Arkansas Nuclear One, Unit 2  
Docket No. 50-368  
License No. NPF-6

Response to NRC Request for Additional Information on ANO-2 Reactor  
Coolant Pump Flywheel Inspection Interval

**Response to NRC Request for Additional Information  
Regarding ANO-2 Flywheel Inspection Extension**

FIGURE 1

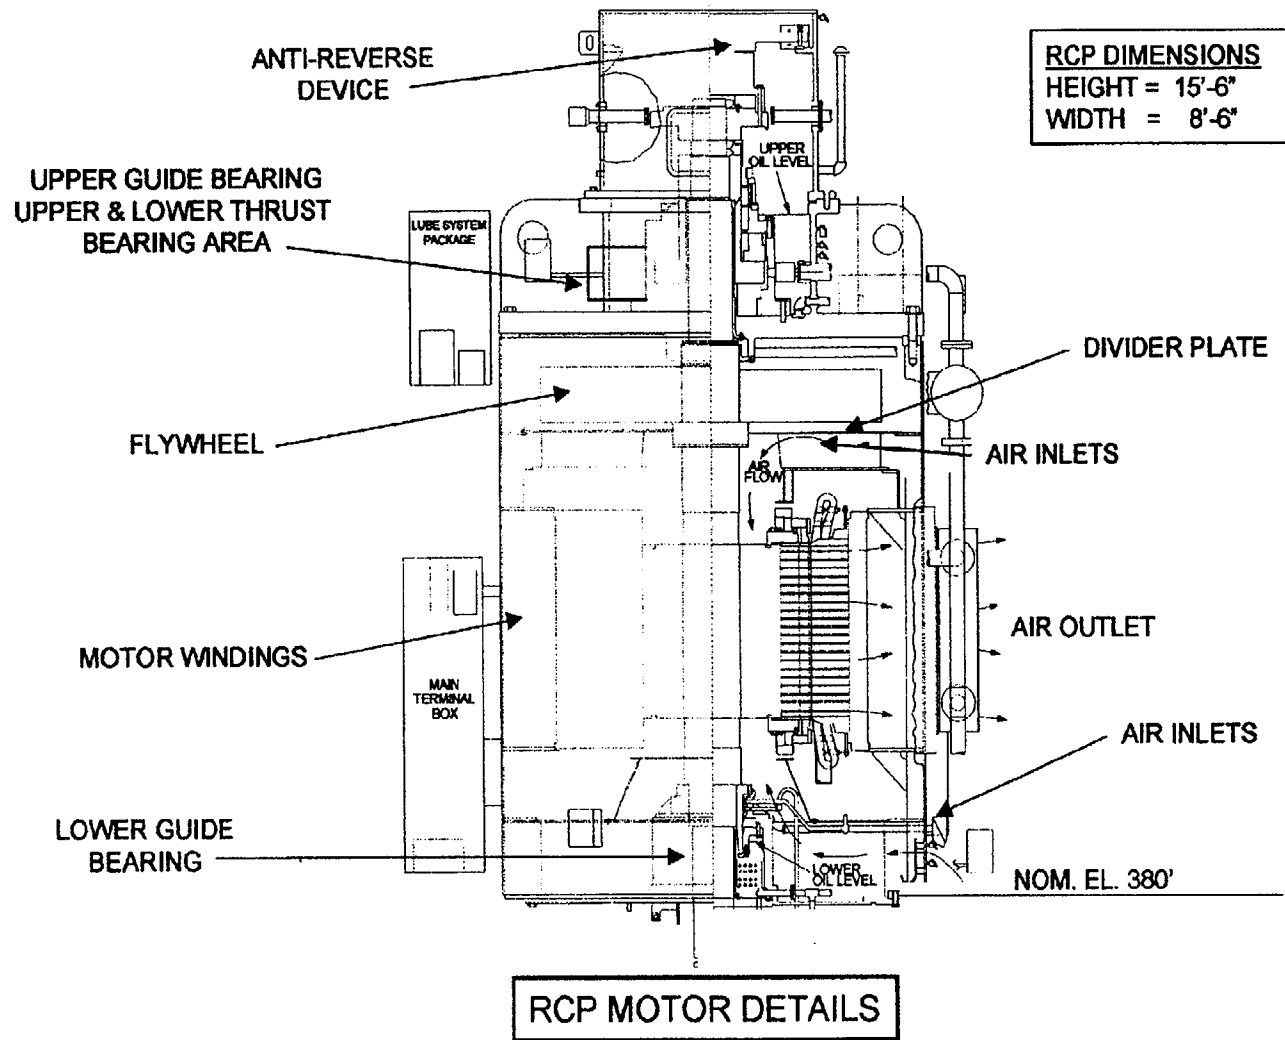
The licensee did not provide any basis for using the nil-ductility transition temperature (NDT) as the reference temperature ( $RT_{NDT}$ ) for the RCP flywheel material. Based on the two Charpy test data of 63 ft-lbs. and 105 ft-lbs. performed at 150°F, the NRC staff used the American Society of Mechanical Engineers (ASME) Code procedure and determined that the  $RT_{NDT}$  value of the RCP flywheel material is 90°F instead of 10°F as stated in the submittal, and the fracture toughness ( $K_{IC}$ ) is 50 ksi square-root-inch instead of 180 ksi square-root-inch as stated in the submittal. Provide additional information to support your  $RT_{NDT}$  value of 10°F. If you plan to propose an alternative methodology in determining the  $K_{IC}$  value to replace the use of the  $K_{IC}$  versus (T- $RT_{NDT}$ ) curve in the ASME Code, you need to submit a relief request.

As noted above, the RCPs run at substantially hotter temperatures than the surrounding air temperatures since they are a source of heat load to the cavity temperatures. As shown on Figure 1, the flywheels are located above the motor windings and below the anti-reverse device and the thrust and upper guide bearings. The RCP stator windings are cooled by drawing air from air inlet locations below the RCP flywheels and then discharging through the stator outlet ports below the RCP flywheels. The flywheel is separated from the stator compartment by a divider plate at the top of the air inlets. The flywheels receive a small amount of cooling air as it is drawn into the motor. The RCPs have installed temperature indicators at various locations throughout the motors. Table 1, with corresponding locations shown on Figure 1; provide a listing of various component temperatures in each of the four RCP motors. This data was collected for the period from January 2001 to January 2002. All components show an average temperature of no less than 122°F. The stator windings provide the greatest heat load from the RCPs, which have average temperatures of greater than 180°F. Even though the flywheel does not have temperature indication, the compartment containing the flywheel is immediately above the compartment containing the motor windings. It is expected that the flywheel compartment will receive significant heat load through conduction and convection from the adjacent compartment with the motor windings. This will provide additional warming of the flywheels.

Therefore, Entergy believes that the overall operation of the RCPs is well in excess of the ambient air temperature and that the flywheels operate at a temperature well in excess of

112°F. As provided below, Entergy has elected to perform the fracture toughness evaluation at a conservative nominal operating temperature of 112°F, as follows.
